Independence and Larimer Park Renovations

Bid # 24-06

ADDENDUM No. 1

March 6, 2024

5 BACKSTOP - SIDE ELEVATION
SCALE: 1/4" = 1'-0"

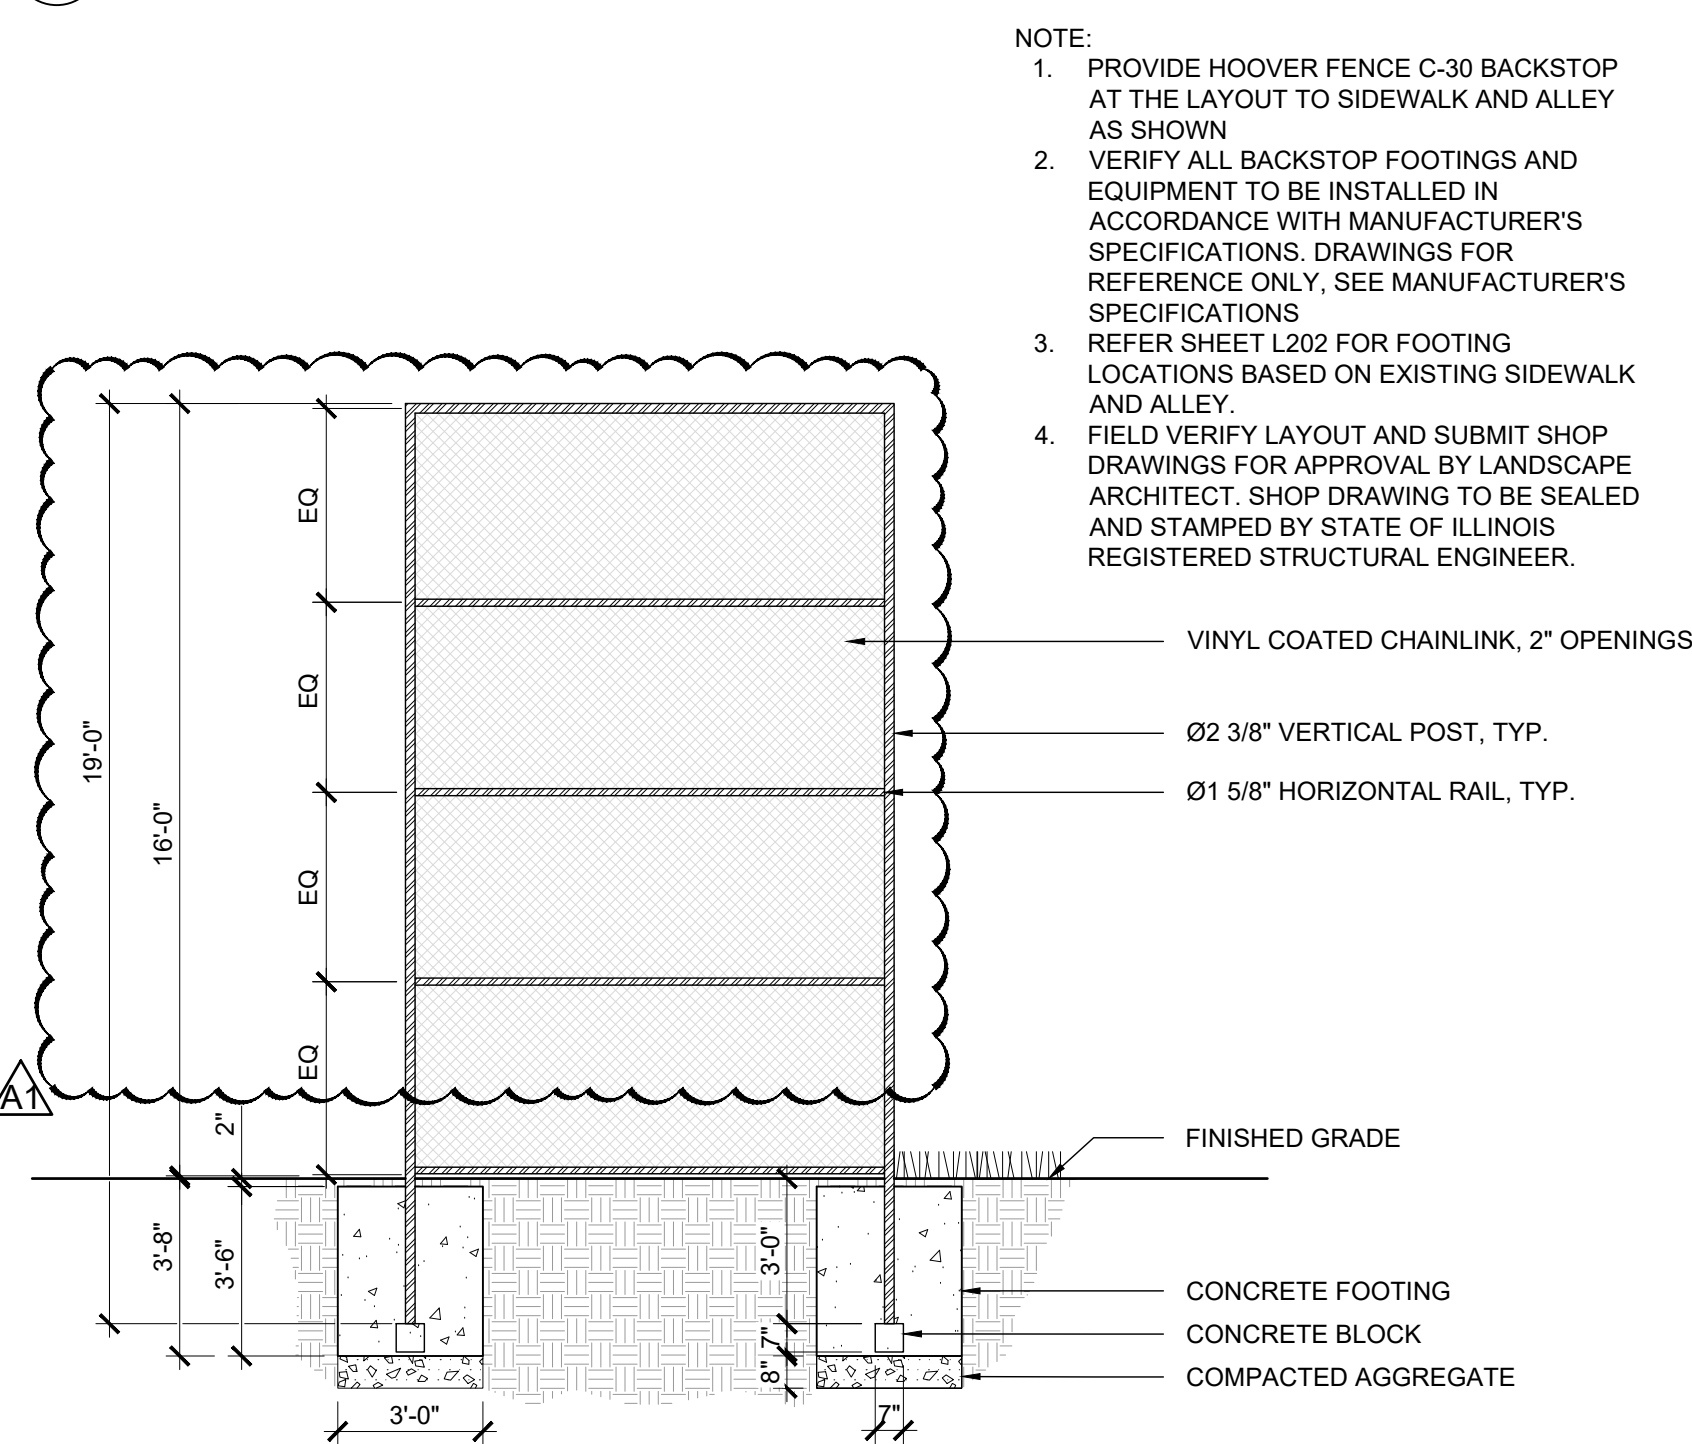
Sheet L304, Detail 5: Backstop – Side Elevation

- Overall height of backstop has been revised
- Quantity and spacing of horizontal rails has been revised

6 BACKSTOP - BACK ELEVATION
SCALE: 1/4" = 1'-0"

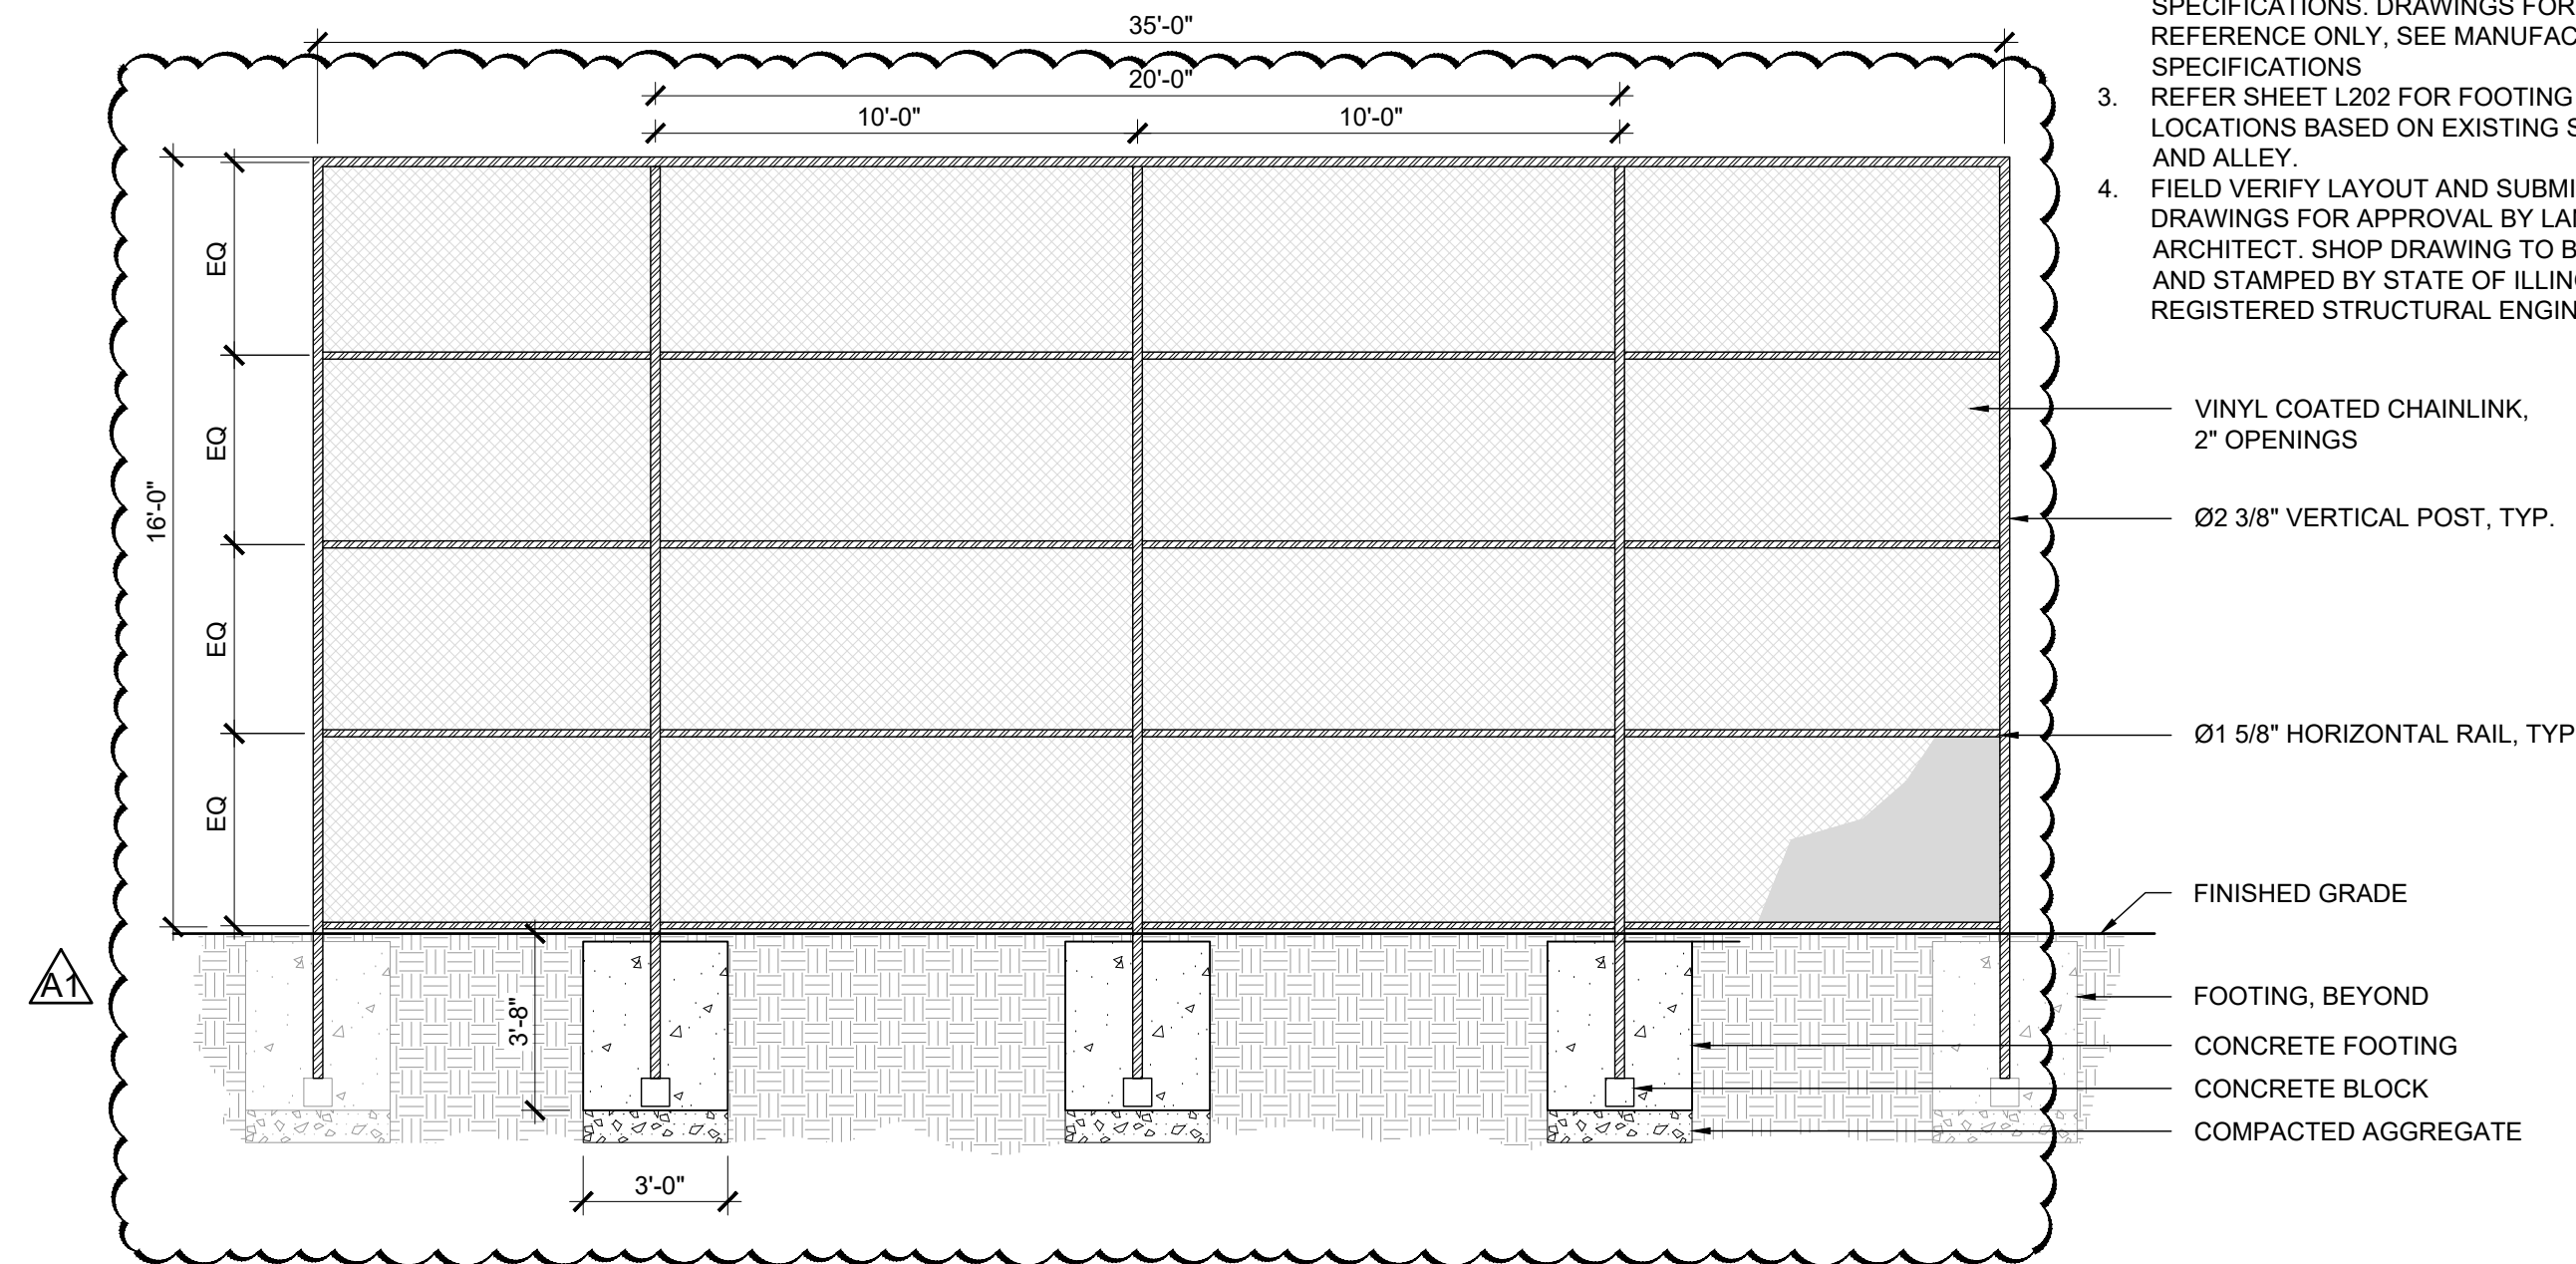
Sheet L304, Detail 6: Backstop – Back Elevation

- Overall height of backstop has been revised
- Quantity and spacing of horizontal rails has been revised
- One vertical post has been added

4 TREE PLANTING IN TREE GRATE

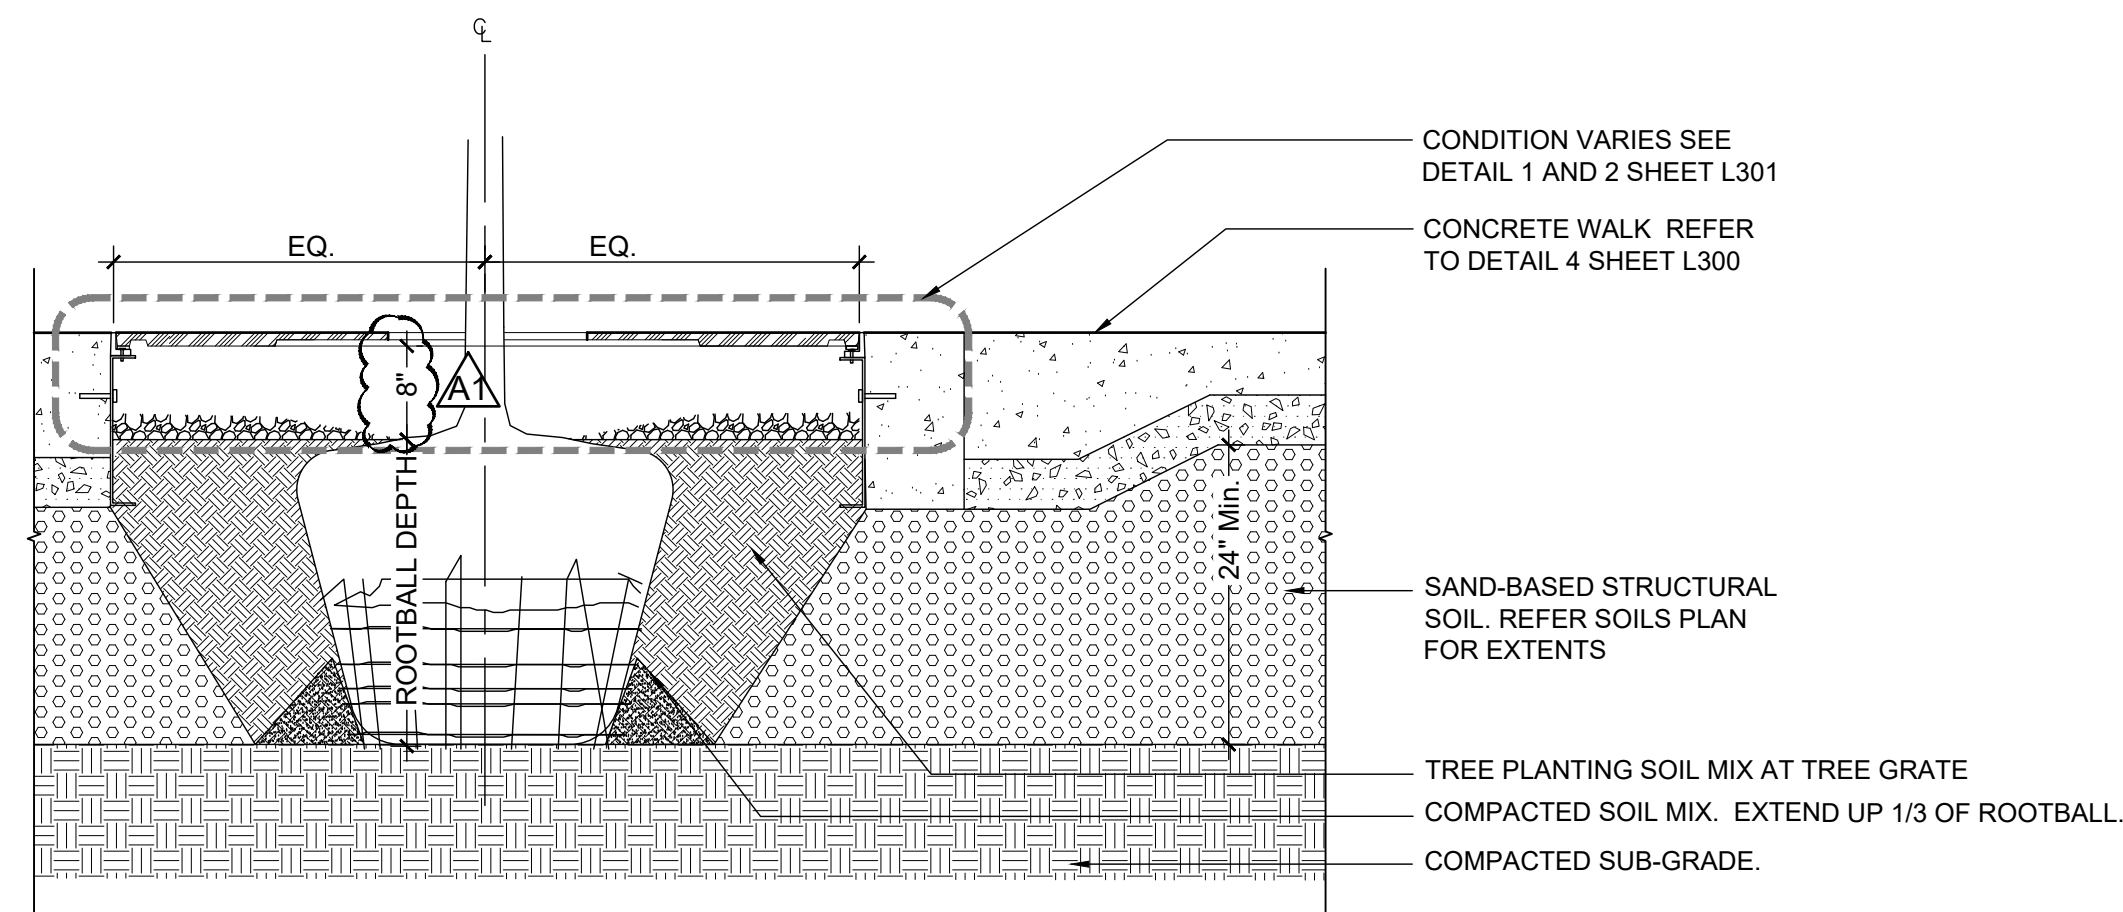
Sheet L310, Detail 4: Tree Planting in Tree Grate

- Depth of tree rootball has been revised
